H Grade Options for I-70: 4% vs. 7%

H.1 Context¹

For the “FRA Developed Option,” the Steering Committee raised a number of questions regarding the consulting team’s inclusion of a 4% grade option via Pando rather than 7% grades on Vail Pass. This Appendix documents the rationale for that choice. The consulting team has recommended that 4% grade options developed in this study be retained for detailed analysis in the Environmental evaluation. 7% grades could technically work, but including them would significantly add implementation risk and raise equipment capital and operating costs. In contrast, 4% grades are manageable using off-the-shelf rail or maglev technology, and would lower operating costs.

**Exhibit H-2: Copper Mountain to Vail via Pando or Vail Pass
 Showing Alternative Vail**

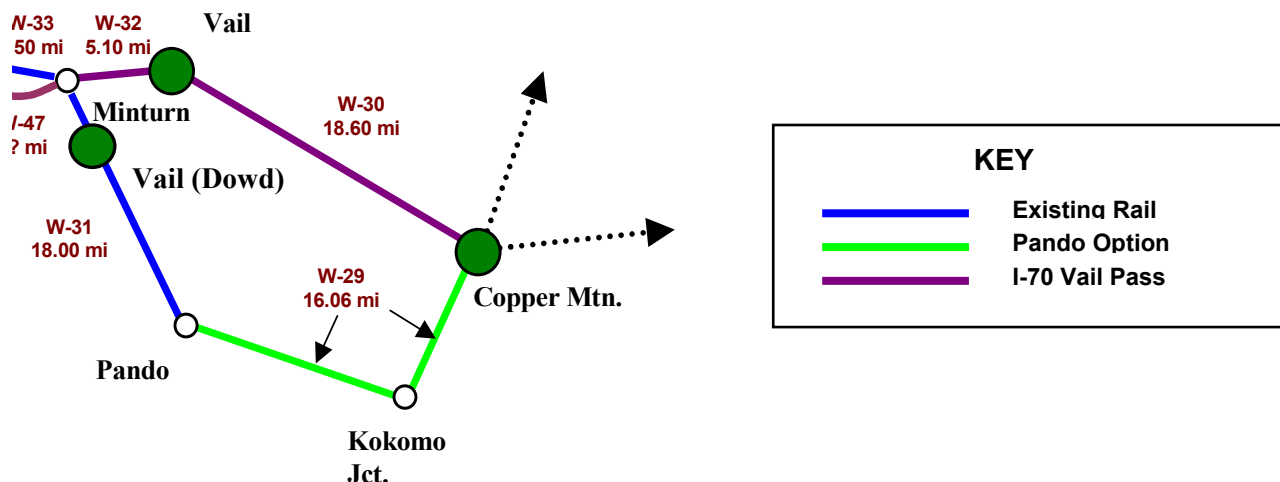
⁴ Developed in response to Comments Matrix Q116 and Q130

Exhibit H-2 shows a portion of the Costing Segments schematic showing the two possible alignments from Copper Mountain to Dowd Junction. The Vail Pass option consists of two segments: W-32 and W-30; while Pando consists of W-29 and W-31. The Pando option utilized in the FRA Developed Alternative does not include a spur into Vail, as agreed with the Steering Committee: the Vail station would be at Dowd Junction for this alternative, and downtown Vail for the Vail Pass (I-70) option.

The Pando route is \$354 million less expensive than the Vail Pass alignment. While there is potential to “Optimize” the Vail Pass route, it should be recognized that because of maintenance of traffic concerns on I-70, difficult topography and adjacent commercial/residential development, the implementation of this alignment will be very challenging. Starting at Copper Mountain, the topography is very difficult for 16 miles. The Vail Pass alignment would be elevated in this area.

Overall, Pando would be \$353.7 Million cheaper and has much more manageable grades. The grades can be less because the route is slightly longer in mileage. Grades via Pando are mostly only 2-3% with only short stretches of 4%.

Exhibit H-3: Equipment Trade Offs for 4% vs. 7% Grade Options

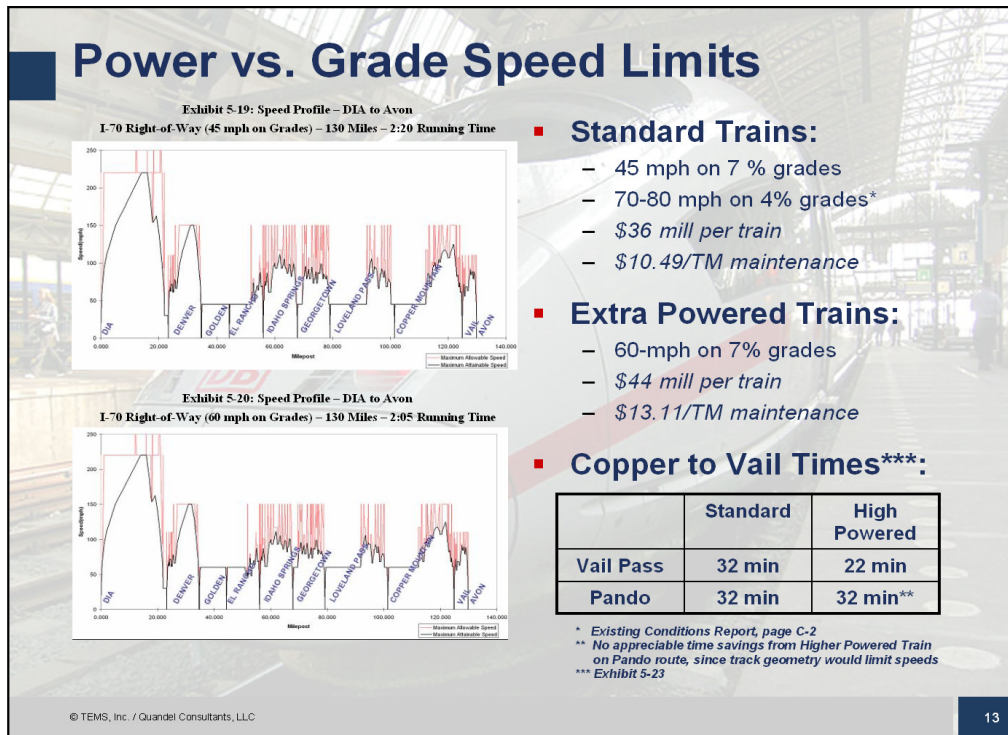
⁵ Developed in response to Comments Matrix Q100, Q102, Supp A Gonzales pg 9-22, Supp G Hall alt calc

Exhibit H-3 shows that if 7% grades via Vail Pass were included in addition to those over El Rancho, there would be a need to buy substantially more costly trains because of the need for the added power. Standard trains could operate on 7% grades, but the best they could do would be 45-mph. Added power could boost speeds to 60-mph, which is the maximum the curves would allow. However, as shown in Exhibit H-3, adding power is expensive: raising capital cost from \$36 to \$44 million per train costing \$400 million; and train maintenance costs from \$10.49 to \$13.11 per train-mile, costing \$510 million over a 30-year life of the system.

While the Vail route is shorter than Pando, schedule times of 32 minutes via either route would be the same for standard trains. A 10-minute savings is possible using Vail Pass if high-powered trains, which will cost more money than those assumed for the Pando alignment, are used. This results in a trade off: Pando is less expensive using standard trains for the same timetable. Vail Pass has higher operating costs, infrastructure and vehicle capital. However, it would be slightly faster than Pando if high-powered trains were used and could directly serve downtown Vail. These options should be explored in a future study.
